BUILDING CODE OF AUSTRALIA 2022 FINAL BCA REPORT

PROPOSED SENIORS LIVING DEVELOPMENT

16 – 22 Funda Crescent Lalor Park NSW 2147

Type of Markup: Final BCA comments

PROJECT
LALOR PARK SENIOR HOUSING
16-22 Funda Crescent, Lalor Park
360, 361, 362 & 363 DP31954
DRAWING TITLE
GENERAL ARRANGEMENT PLAN - GROUND LEVEL

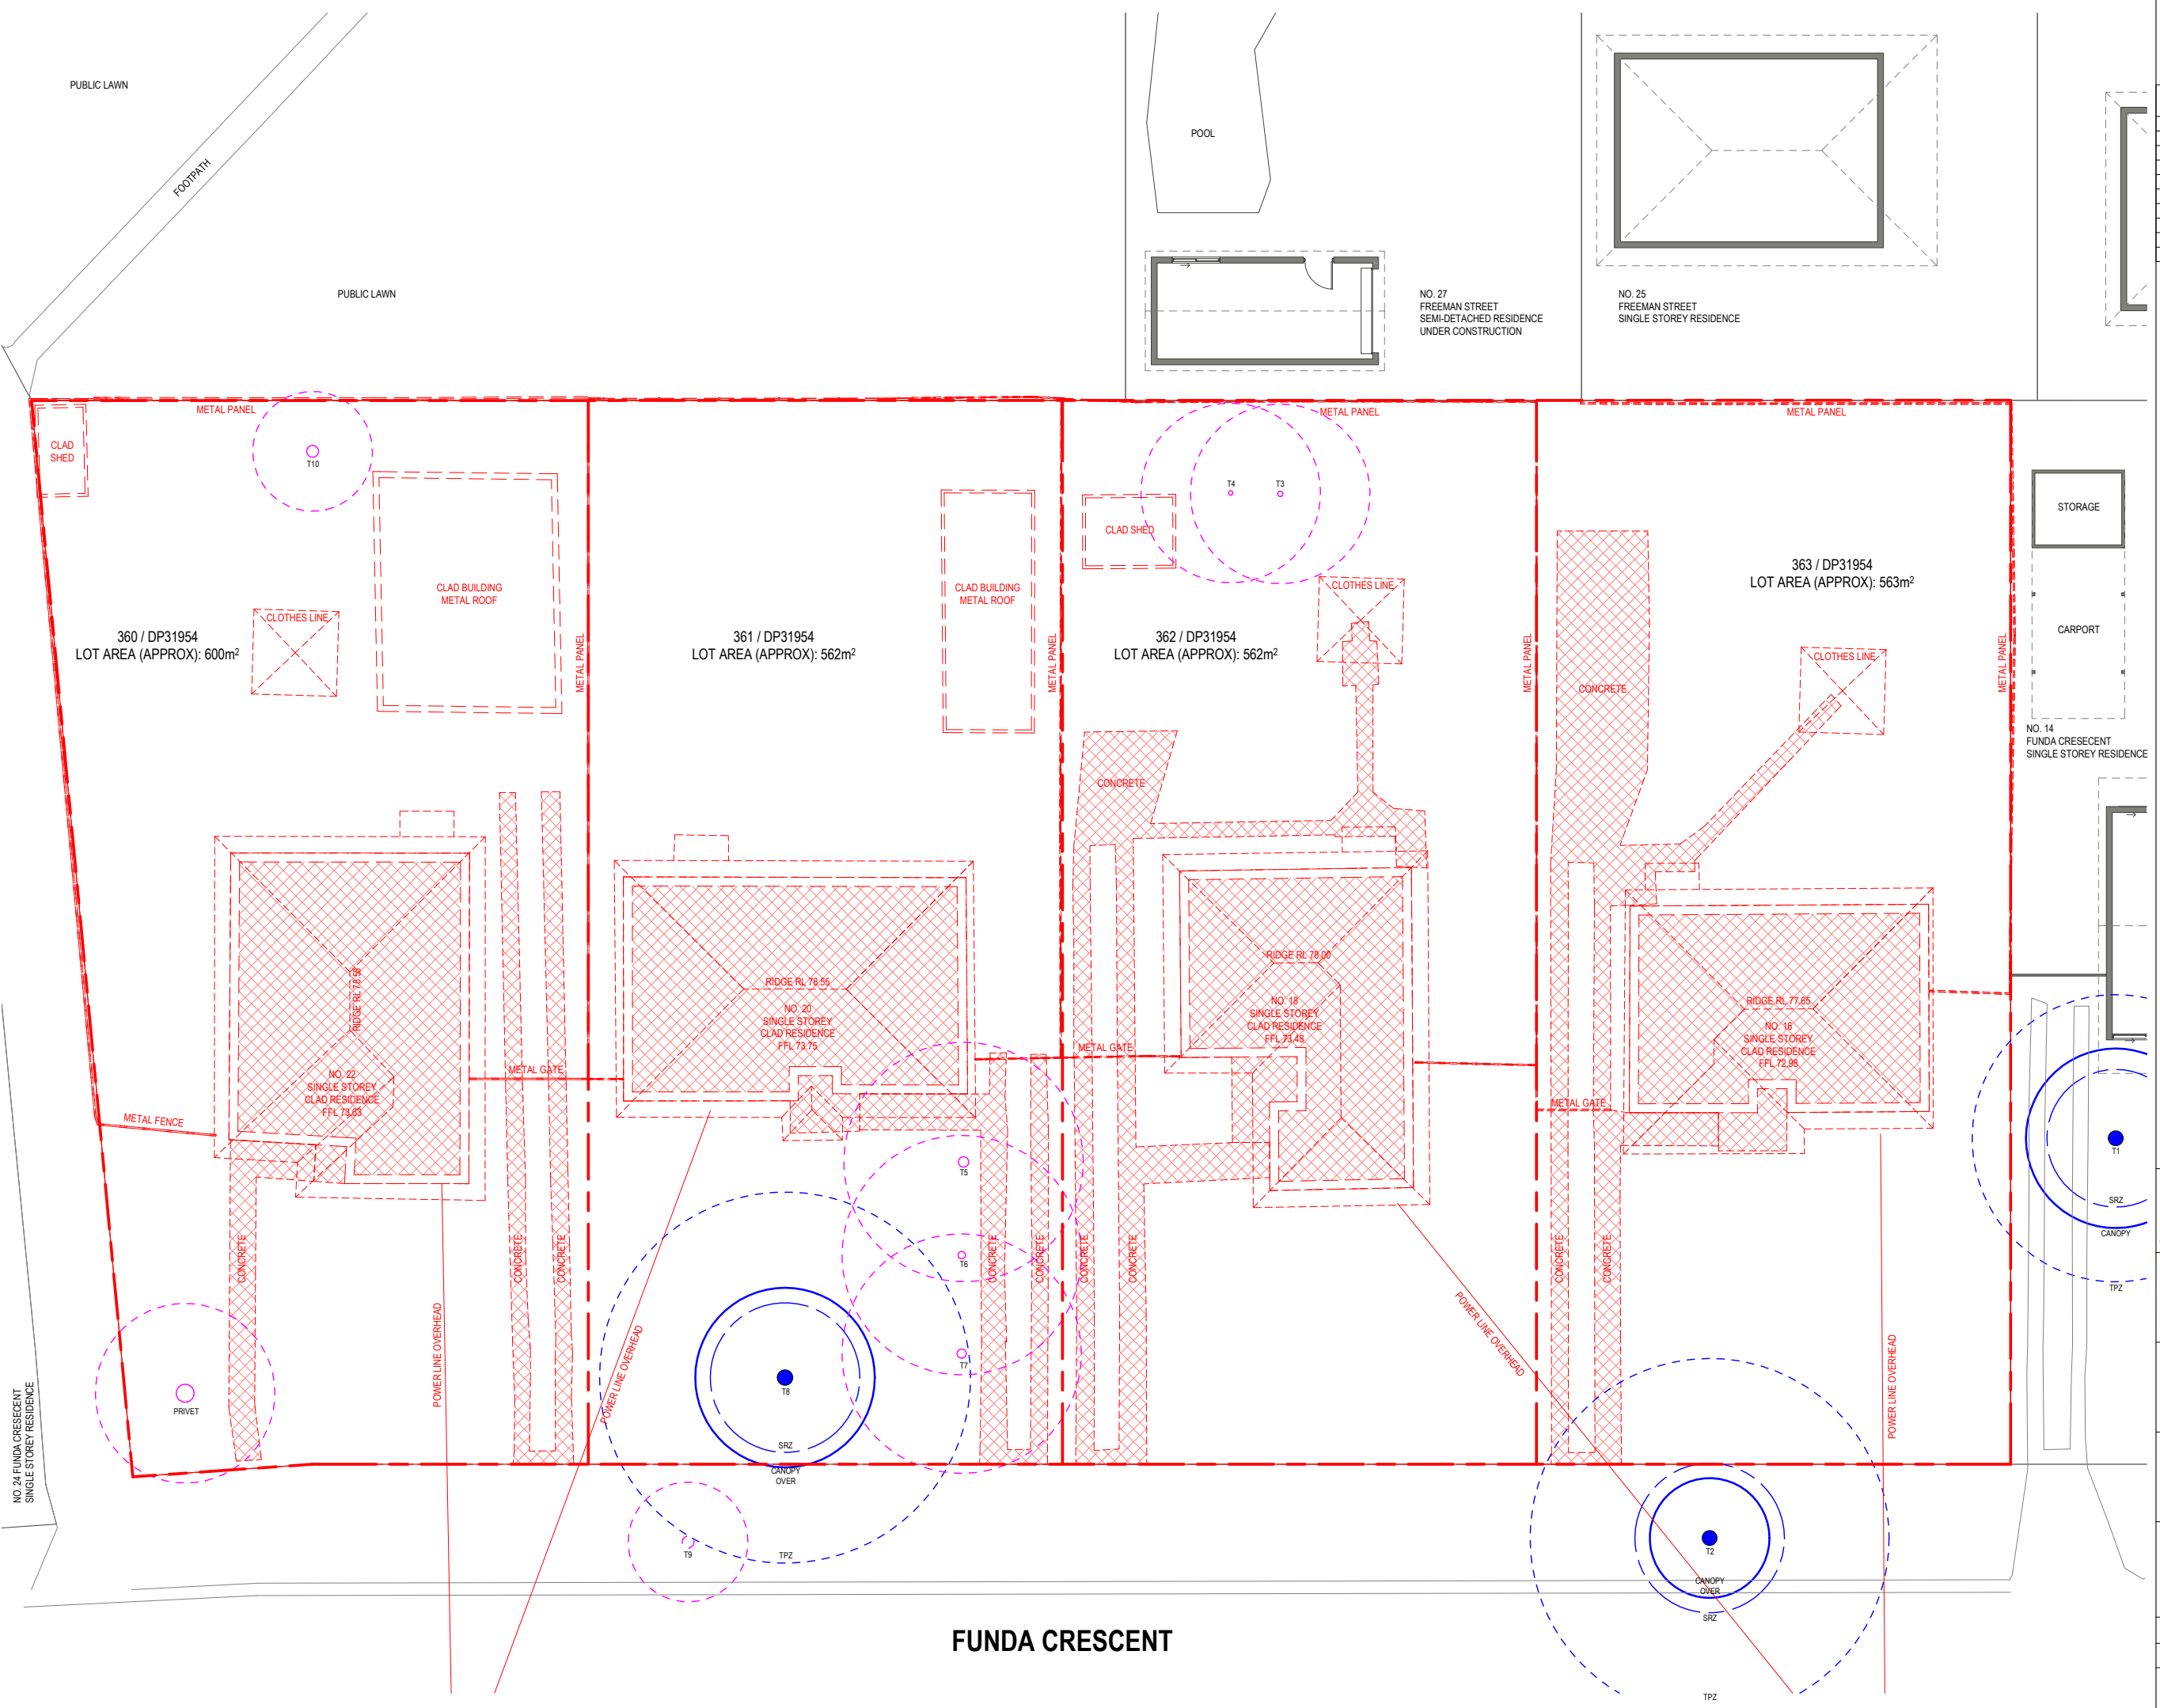
Typical to all unit entry doors - SOU doorways providing access to the corridor must be protected - self-closing, tight fitting, solid core door, not less than 35mm thick to comply with Clause C4D6 & C4D12.

Typical to all floors - Provide locations of portable fire extinguisher

DRAWING TITLE
ELEVATIONS - SHEET 1

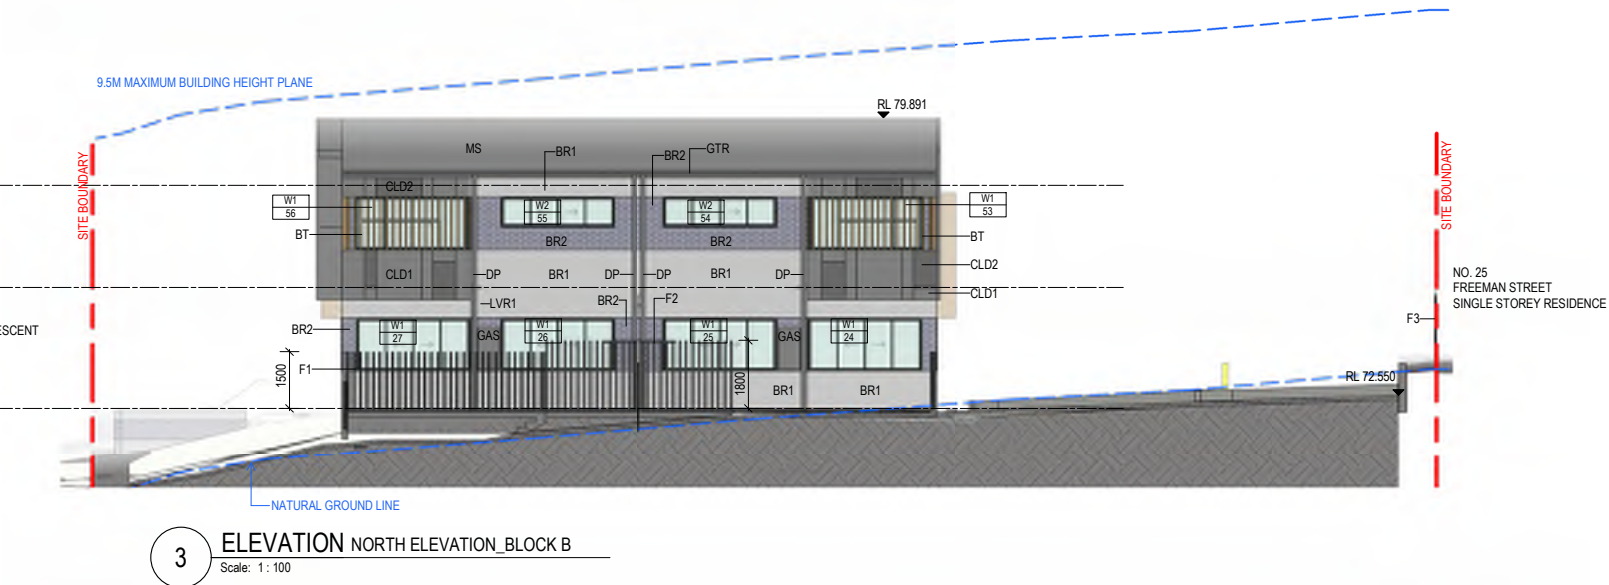
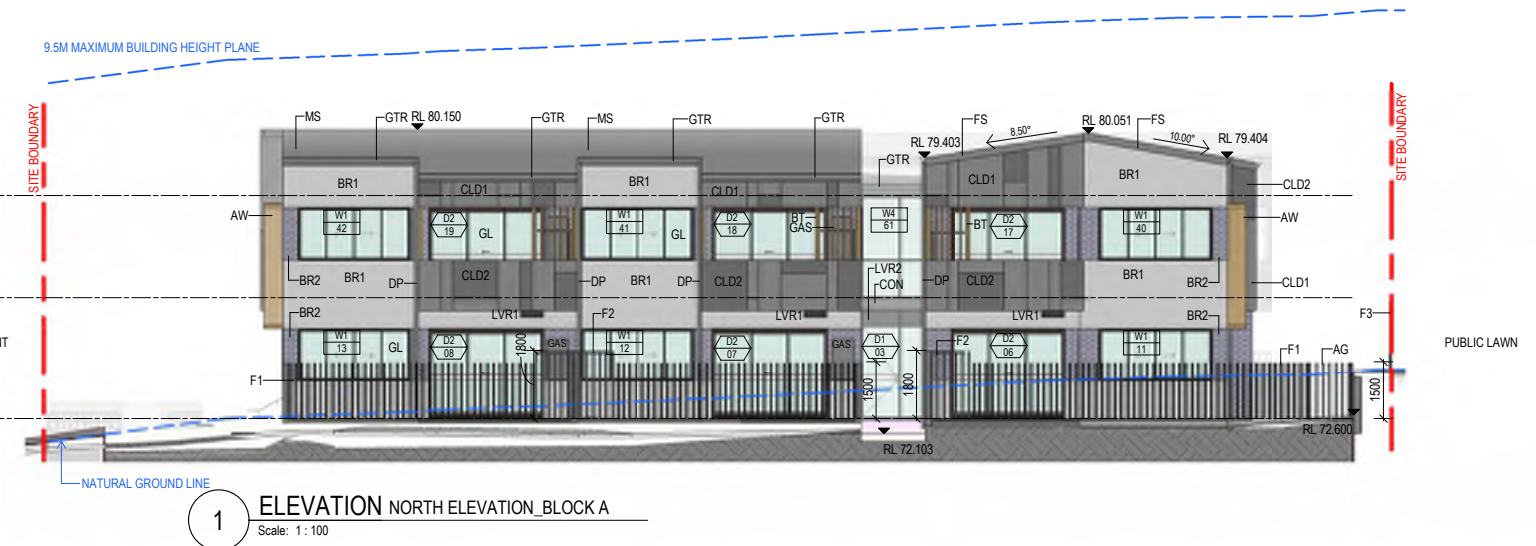
Provide cross sectional wall type details and finishes schedule prior to issue of CDVC.

Provide acoustic ratings on the wall schedule.

Provide FRL for each wall type
